TO ALL EXEC 90 and EXEC 162F OWNERS

MANDATORY COMPLIANCE BULLETIN M-11

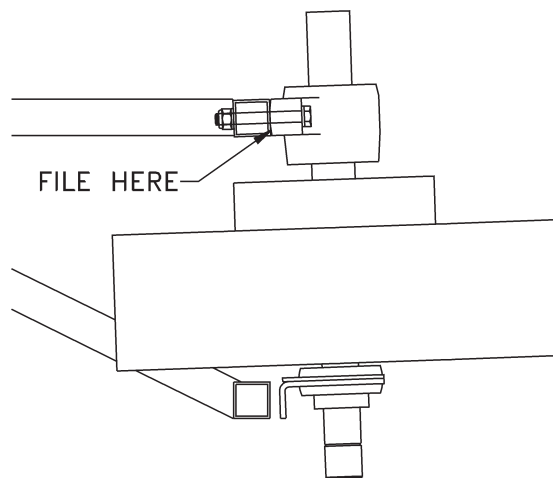
5. Install the enclosed temperature strip on the upper bearing housing of your secondary drive unit as shown in the illustration below. (Clean the area of the housing with acetone or other solvent so that the strip will adhere properly.) The heat sensitive "dots" on the strip will darken if the indicated temperature is exceeded. Check the temp strip during every post-flight inspection.
